re: Heywood Interconnector Upgrade – AER information request

ATTACHMENT A

This attachment outlines ElectraNet and AEMO's responses to the submissions provided to the AER on ElectraNet's clause 5.16.6 determination request, including Frontier Economics' modelling accompanying the Macquarie Generation submission. The three major sections of this response align with the three submissions received by the AER.

Figure 1 – Flow and limits on the Heywood interconnector during one week in December 2012

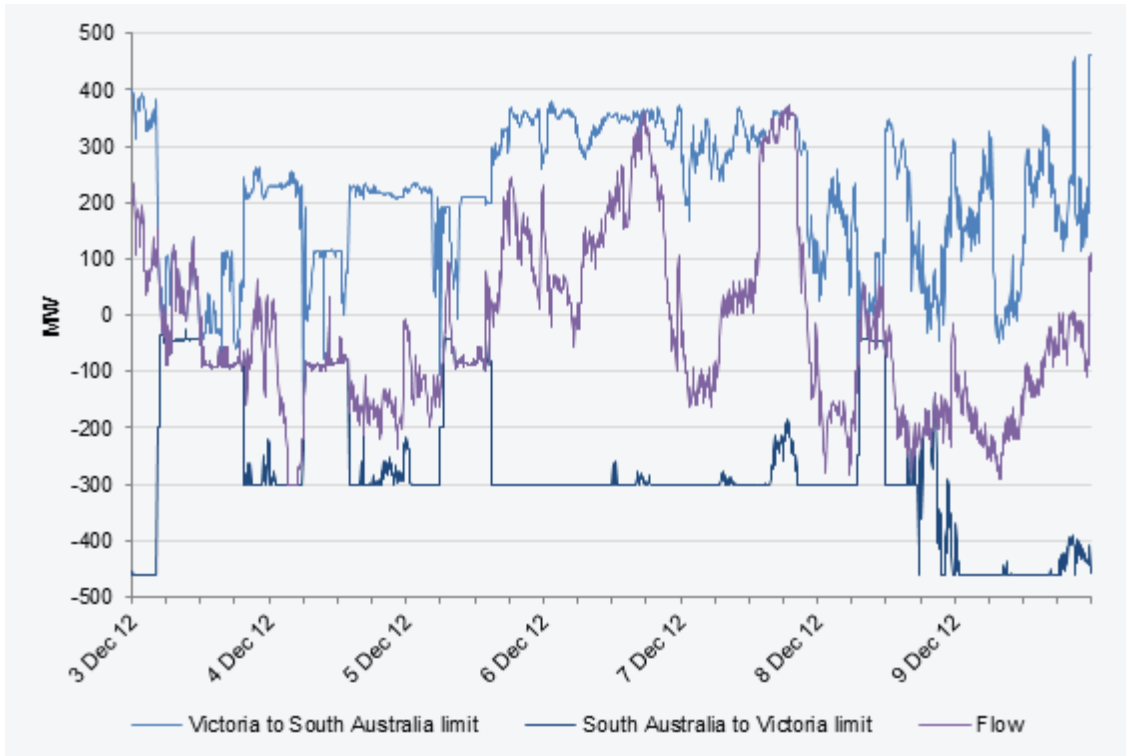
Frontier has “assumed that the interconnector is available bi-directionally at all times up to its full notional transfer limit of 460 MW.” ElectraNet and AEMO consider this assumption does not enable the full market benefits to be measured to evaluate Option 1b accurately. The consequences of this assumption are significant.

Frontier firstly compares the benefits it has calculated with the costs and benefits of Option 1b. This is an unreasonable comparison. The interconnector is frequently restricted at levels below 460 MW. In particular, it is restricted by voltage stability limitations and thermal limits on the 132 kV network. Option 1b specifically addresses both of these limits. The cost of solving these limits in Option 1b is approximately 58 per cent or \$62.7 million. The cost of an additional Heywood transformer is \$37.4 million¹. It is more reasonable to compare the outcomes of Frontier’s studies with the benefits of the third Heywood transformer alone, and only this element of Option 1b.

Figure 1 : Proposed Network Augmentations

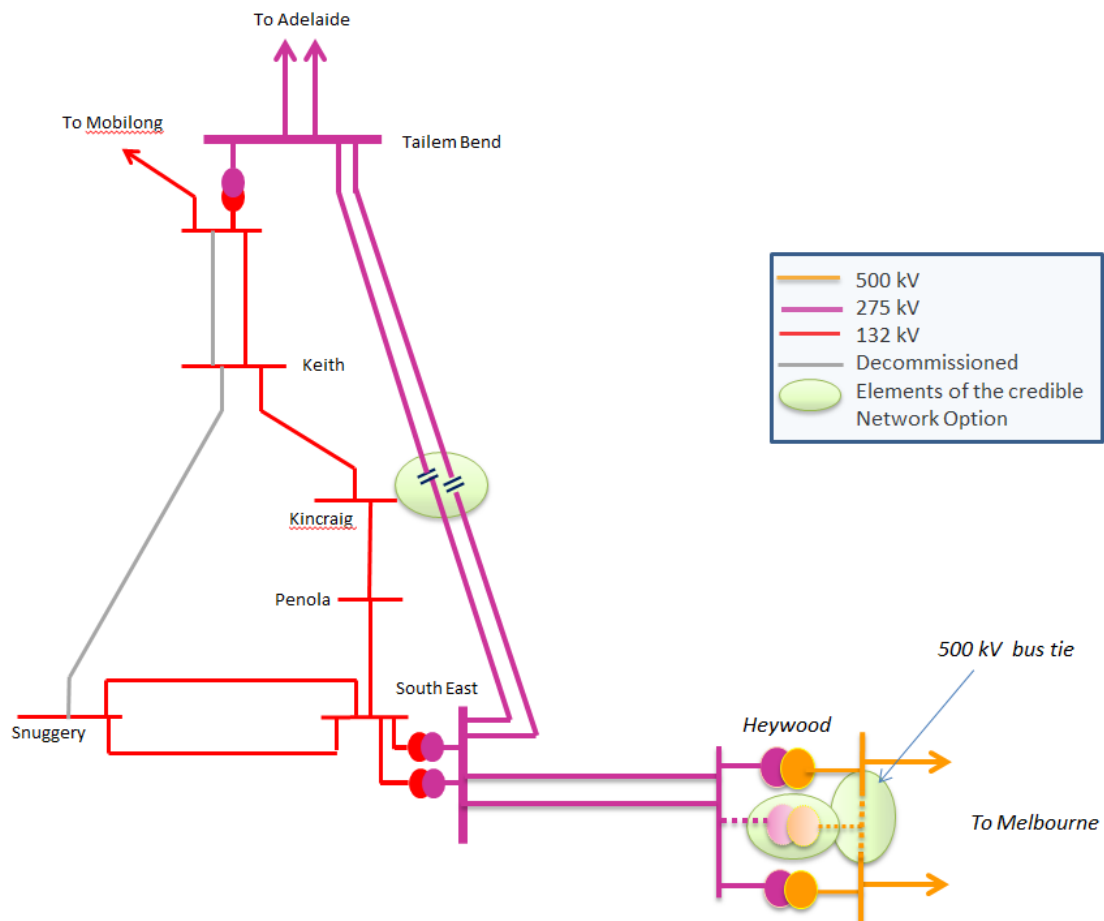
Figure 1 shows the proposed network augmentations related to the Heywood Interconnector RIT-T preferred option. A number of plant and protection limitations on the 275 and 132 kV networks in the South East region of South Australia will also be addressed as part of Option 1b. This is included in the load flow studies.

It may be noted that the weak 132 kV lines in the existing arrangements (shown on Figure 1 in grey) will limit the interconnector import capability to about the existing capability. The proposed augmentation will increase that capability to the new desired capability of 650 MW.

Figure 2: Existing system with 460 MW import (system Normal)

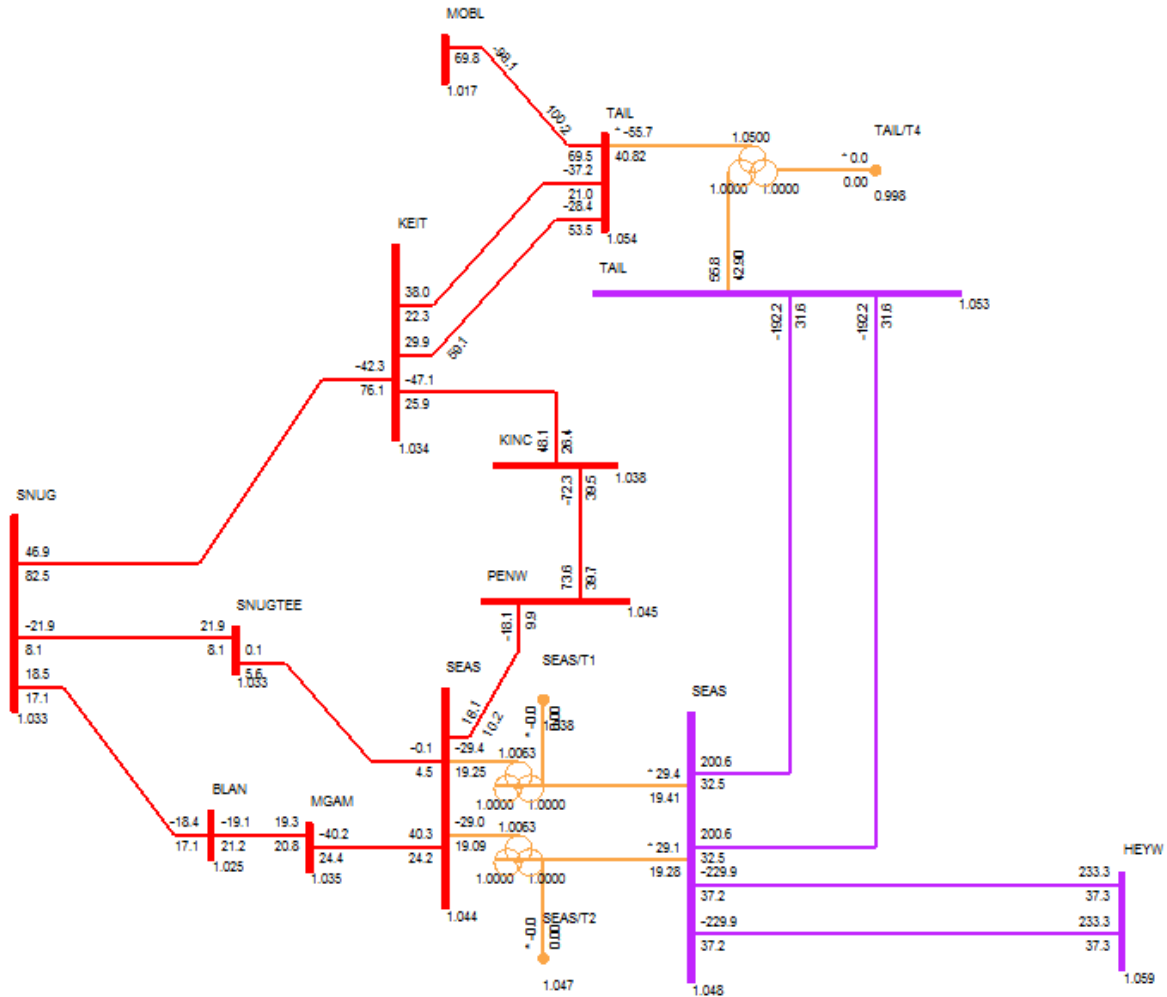
In Figure 2, no contingencies are considered and all lines are within limits.

Figure 3: Existing system with 460 MW import (N-1)

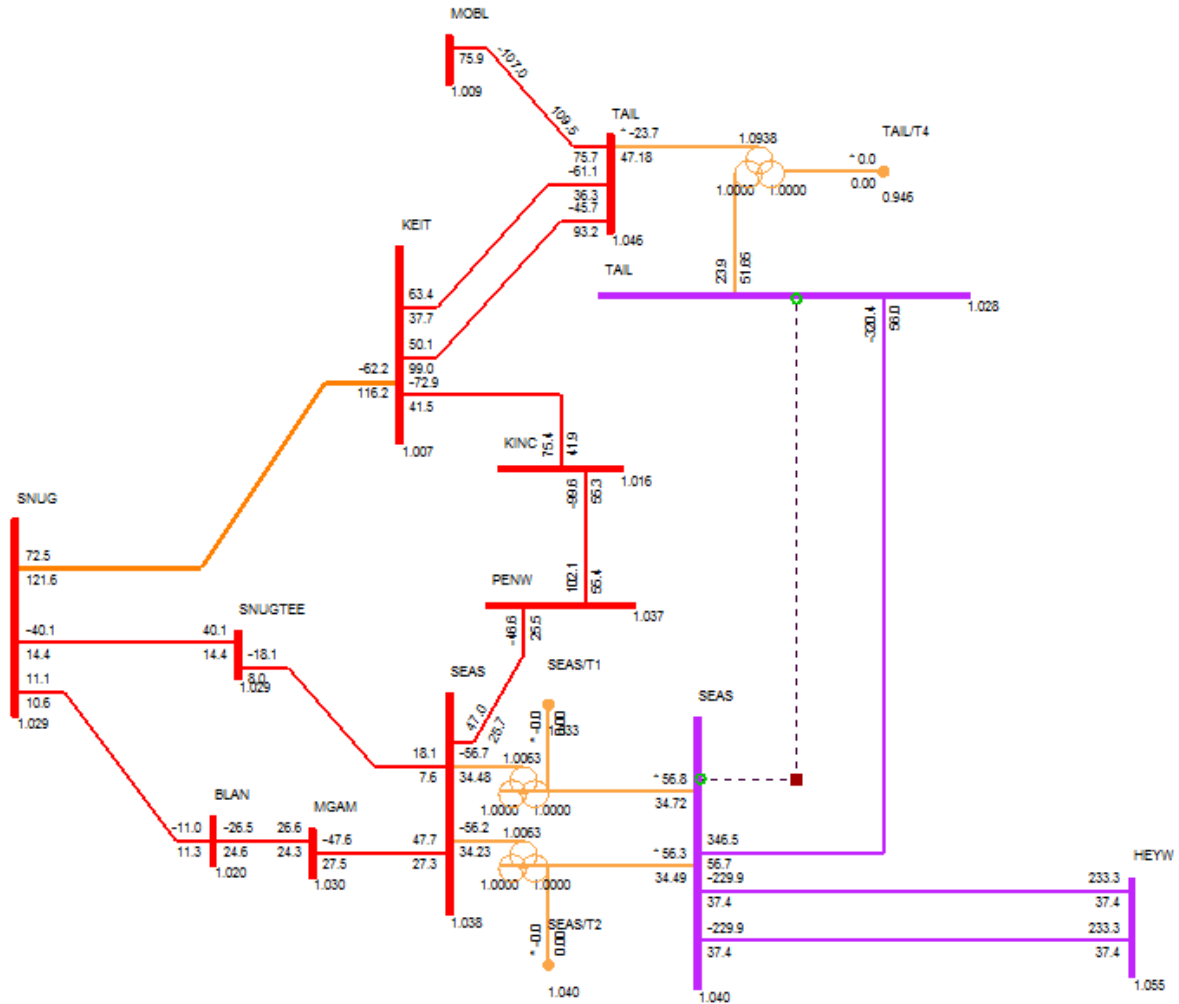
In this load flow – with the consideration of the loss of the South East to Tailm Bend 275 kV line, there is a **22%** overload of the Snuggery-Keith 132 kV line. Constraints will prevent the interconnector and/or generators in the south east from reaching this dispatch pattern due to the overload.

Figure 4: Existing system with 650 MW import (system Normal)

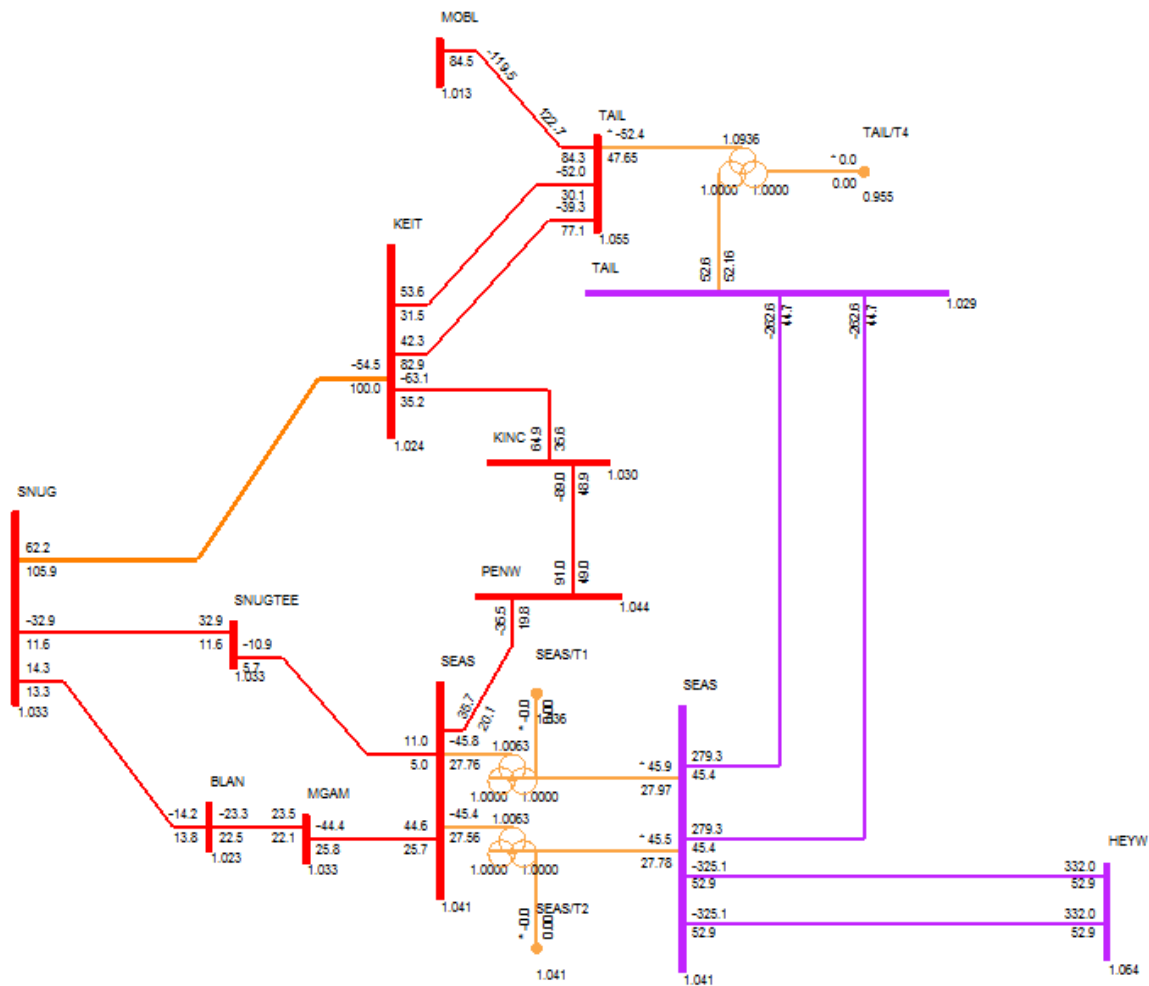
Under system normal conditions, before consideration of contingencies, there is a 6% overload of the Snuggery-Keith 132 kV line with imports of 650 MW from Heywood.

Figure 5: Existing system with 650 MW import (N-1)

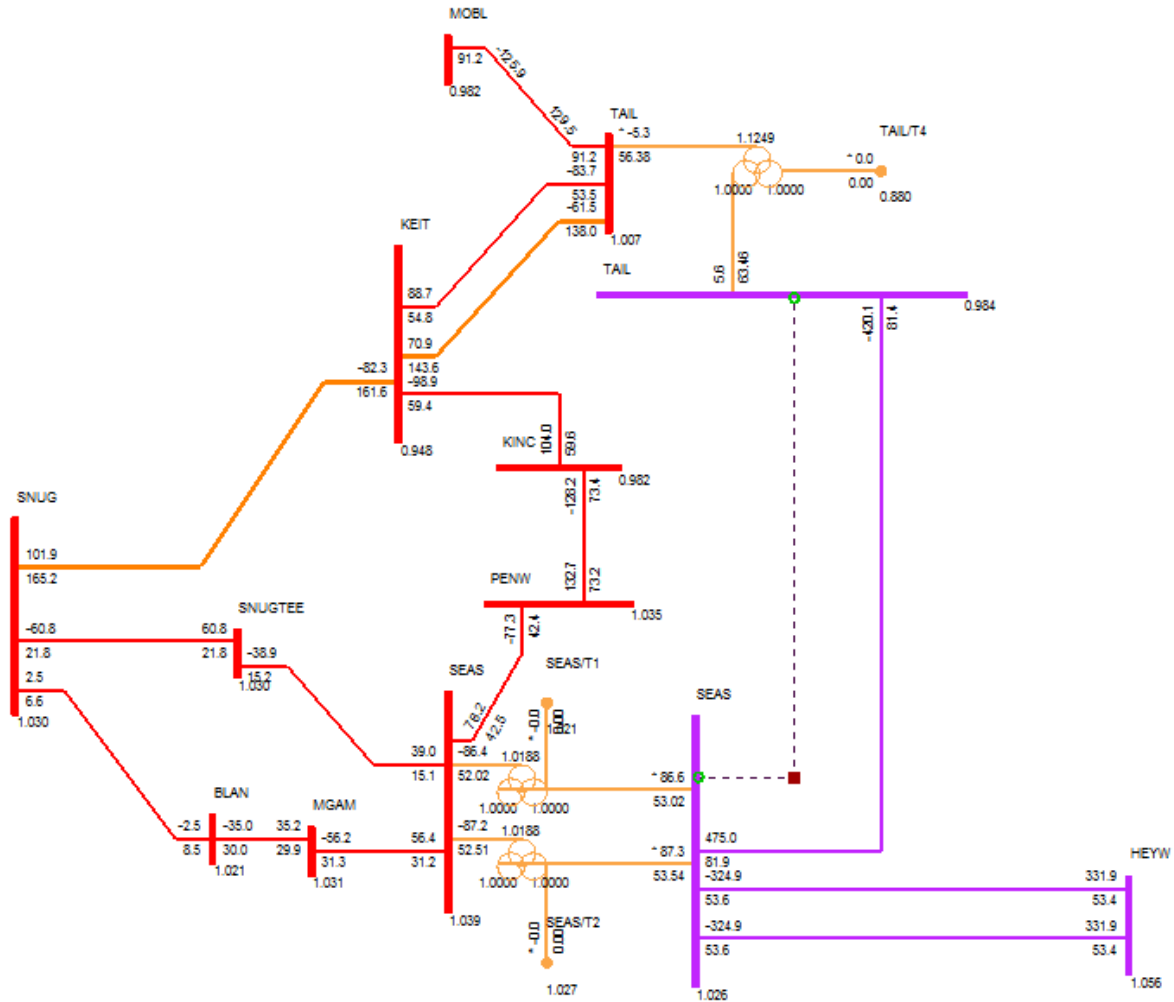
There is a **65%** overloading of the on the Snuggery-Keith line and **44%** on the Keith-Tailern Bend#1 line after consideration of flows after a credible contingency on the South East and Tailern Bend 275 kV line.

Figure 6: Augmented system with 650 MW import (system Normal)

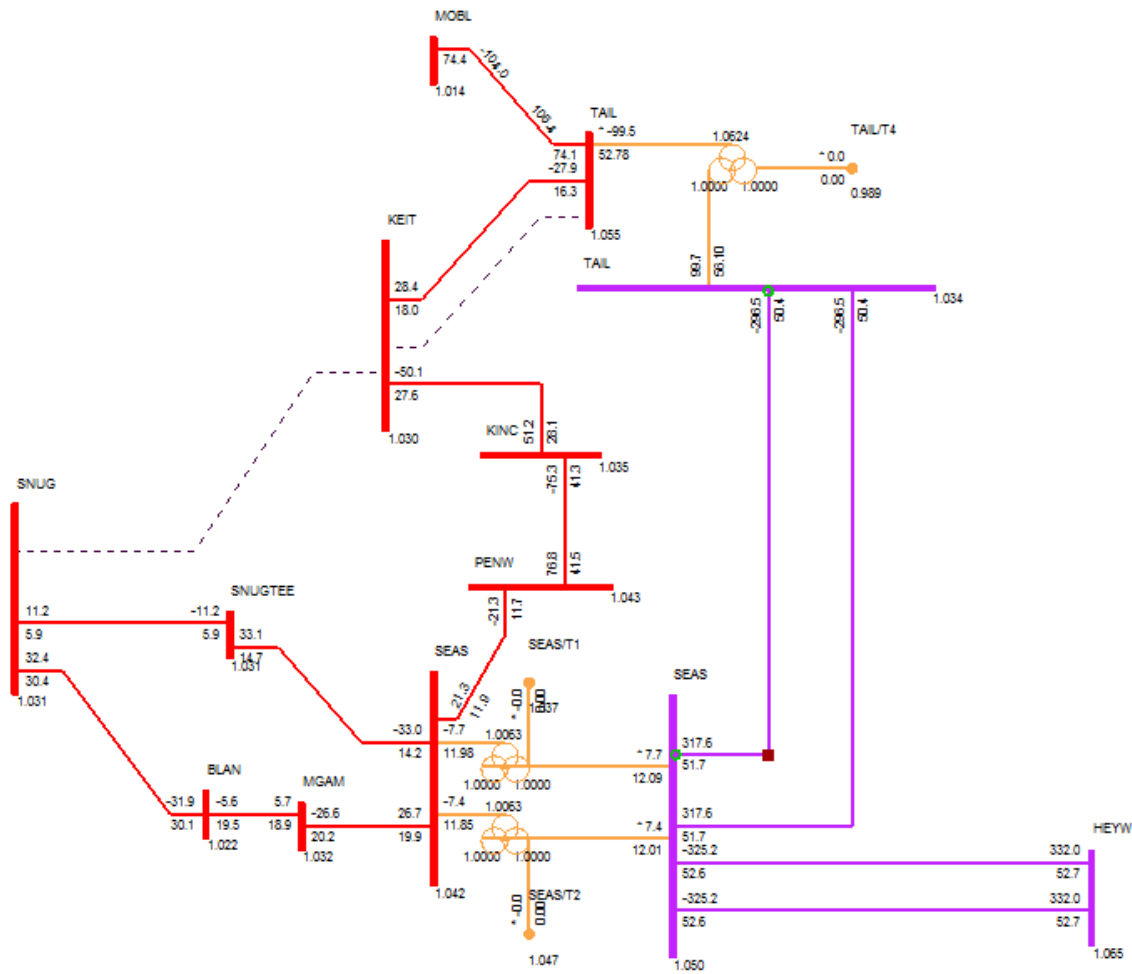
All lines are within limits.

Figure 7: Augmented system with 650 MW import (N-1)

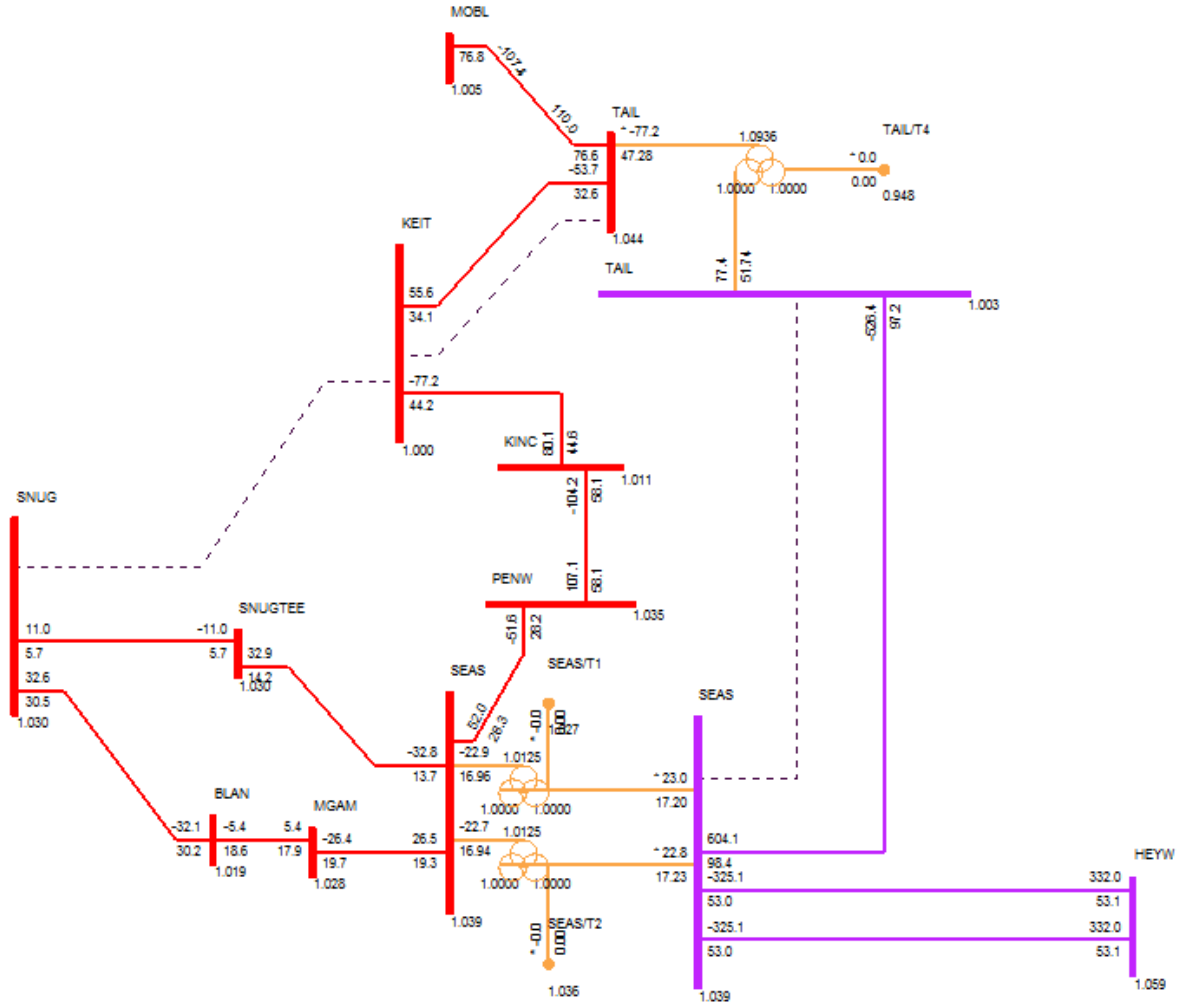
It may be noted that none of the lines are overloaded and therefore no constraints will be applied to the South East generators for high load, high import and low wind generator conditions. This clearly demonstrates that with the proposed network augmentations, the generators in South East will have improved access to the network.

Figure 8: Existing system with 650 MW Export (with contingency of a South East Transformer)

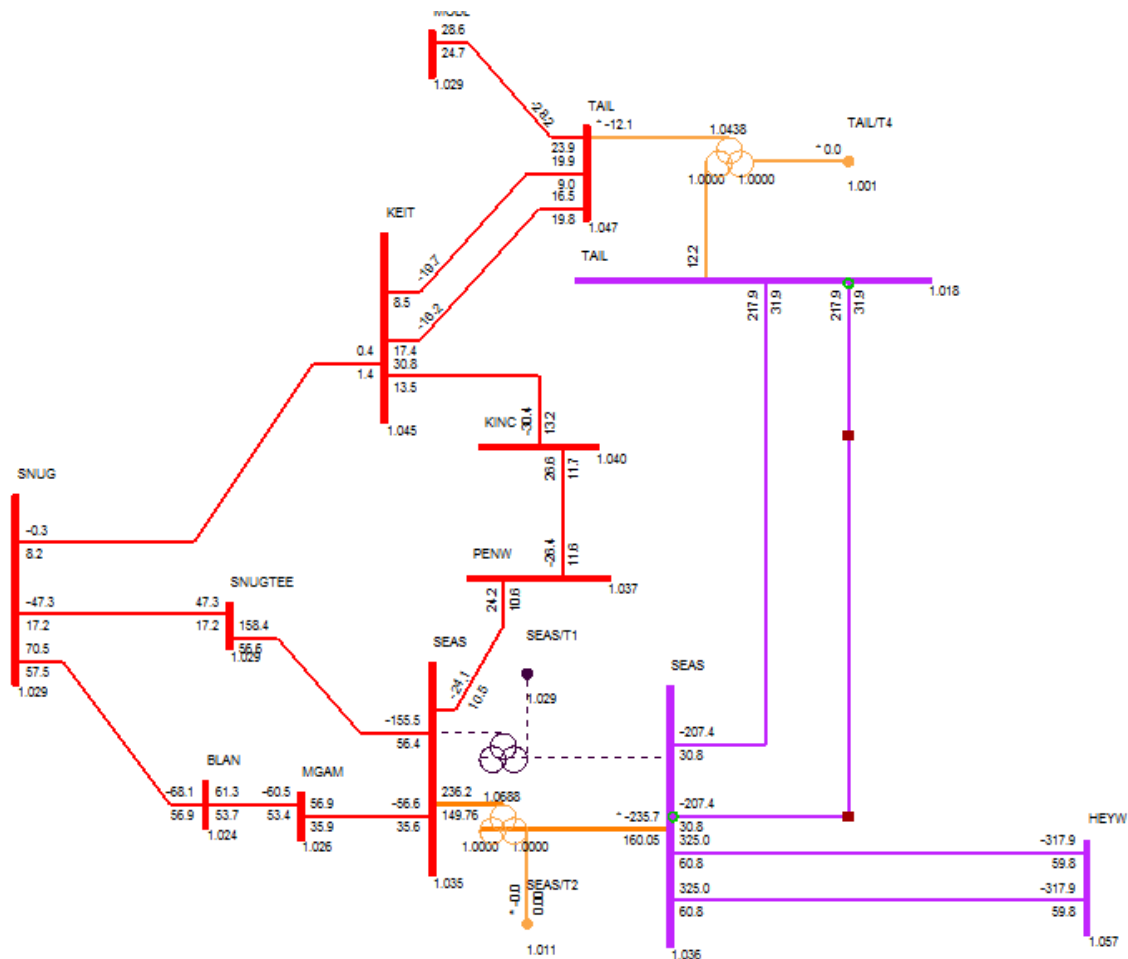
The remaining transformer is overloaded by 60%.
